CITY PLAN COMMISSION**FILE NUMBER:** PLAT-25-000181**THURSDAY, January 15, 2026****SENIOR PLANNER:** Hema Sharma**LOCATION:** White Rock Road at Wildgrove Avenue, northeast corner**DATE FILED:** December 19, 2025**ZONING:** R-7.5(A)**CITY COUNCIL DISTRICT:** 9**SIZE OF REQUEST:** 0.205-acres**APPLICANT/OWNER:** Craig A. Lashley

REQUEST: An application to replat a 0.205-acre (8,930-square foot) tract of land containing all of Lot 1 in City Block 3/2748 to create one lot, and to remove an existing 15-foot platted building line along White Rock Road and to extend an existing 30-foot platted building line along the Wildgrove Avenue to the property line, on property located on White Rock Road at Wildgrove Avenue, northeast corner.

PLAT-25-000181

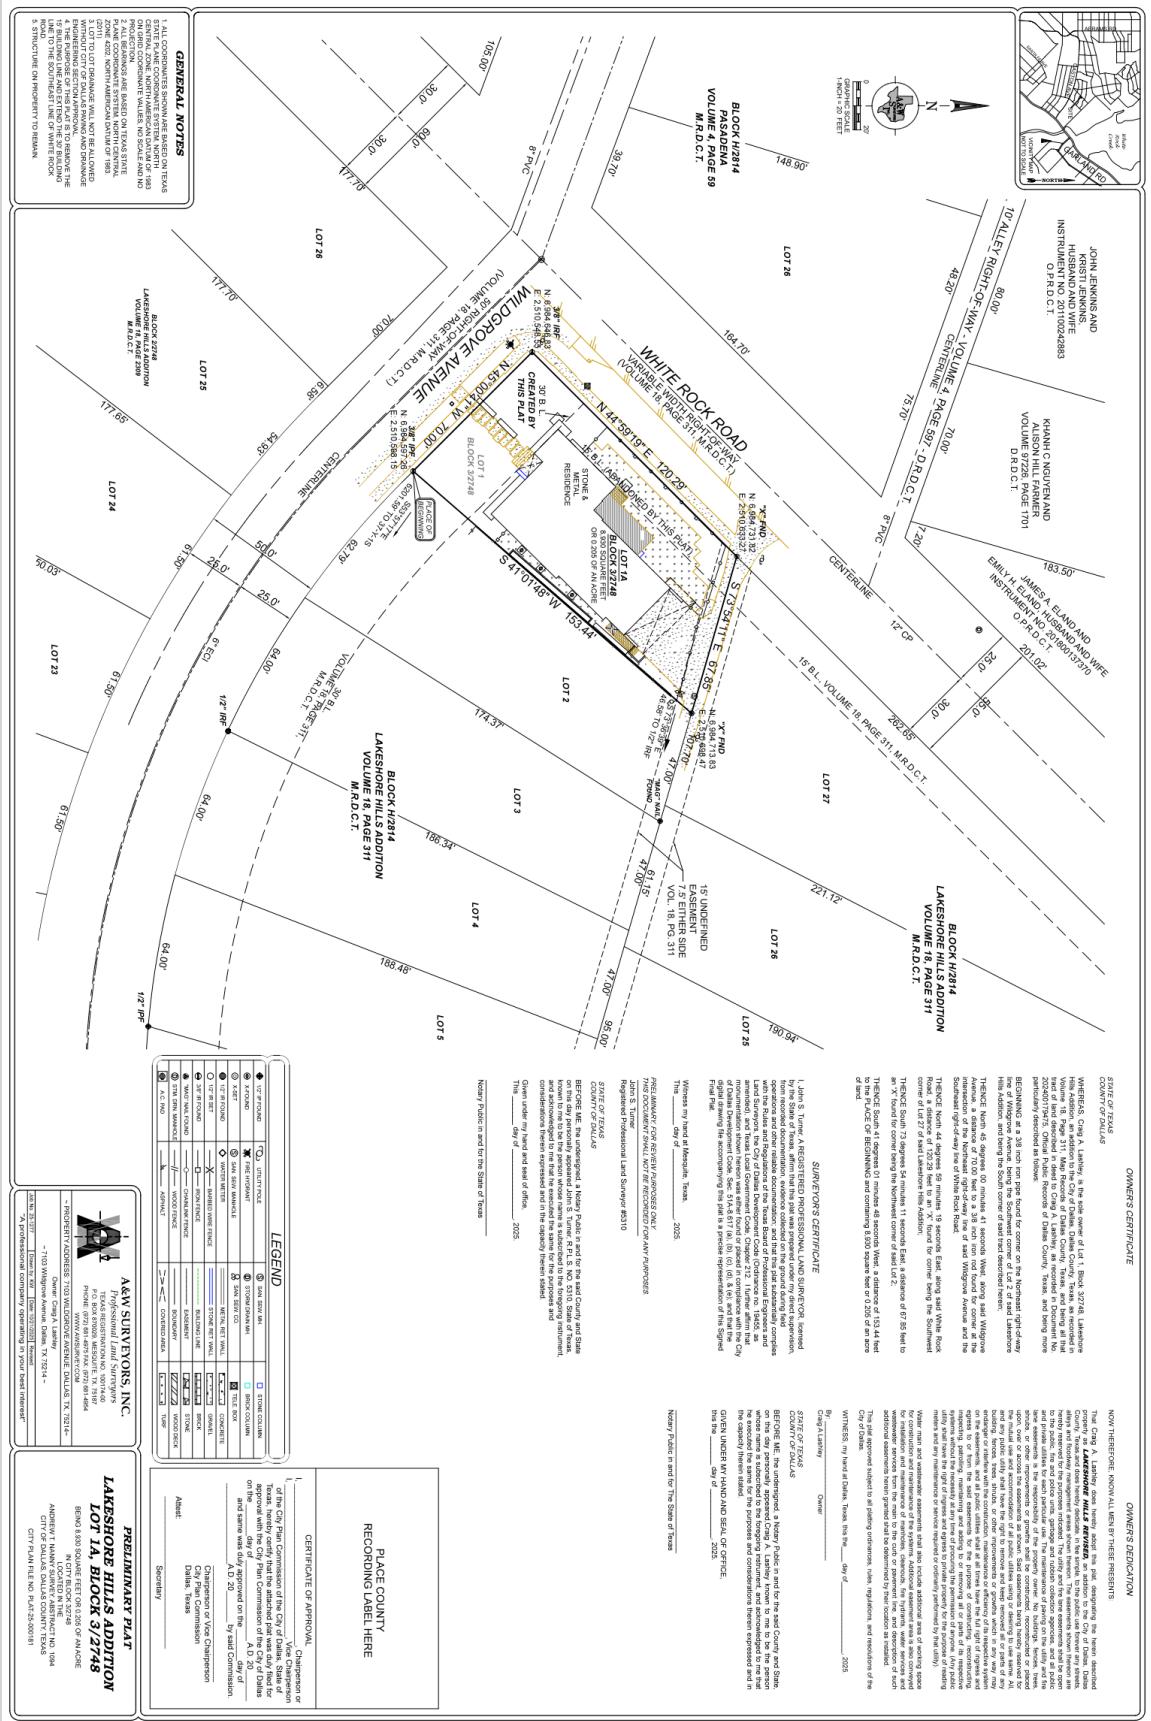
STAFF RECOMMENDATION ON BUILDING LINE REMOVAL: The request is to remove an existing 15-foot platted building line along White Rock Road and to extend an existing 30-foot platted building line along Wildgrove Avenue to the property line. Staff finds that the request does not comply with the requirements of Section 51A-8.505 of the Dallas Development Code; therefore, staff recommends denial of the request.

The request is to create one 0.205-acre (8,930-square foot) lot and the number of lot and lot area remain same. Staff concludes that the request complies with the requirements of Section 51A-8.503 and the R-7.5(A) Single Family District but does not comply with Section 51A-8.505; therefore, staff recommends denial of the request. However, should the request be approved, we recommend the approval be subject to compliance with the following conditions:

14. On the final plat, dedicate 7.5 feet of right-of-way (via fee simple) from the established center line of the Alley. *Section 51A 8.602(c)*
15. On the final plat, dedicate 28 feet of right-of-way (via fee simple or street easement) from the established centerline of Wildgrove Avenue. *Sections 51A-8.602(c), 51A-8.604(c) and 51A-8.611(c).*

16. On the final plat, dedicate a minimum 5-foot by 5-foot corner clip (via fee simple or street easement) at the intersection of White Rock Road & Wildgrove Avenue. *Section 51A 8.602(d)(1)*

18. On the final plat, dedicate a 15-foot by 15-foot Alley Sight Easement at the intersection of White Rock Road & the alley. *Section 51A-8.602(e)*
19. Must coordinate with Transportation Department for any traffic signal requirements that are deemed necessary for improving pedestrian accessibility and safety related to site development (Contact Srinivasa Veeramallu with Traffic Signals). *51A-8.606, 51A-8.608*
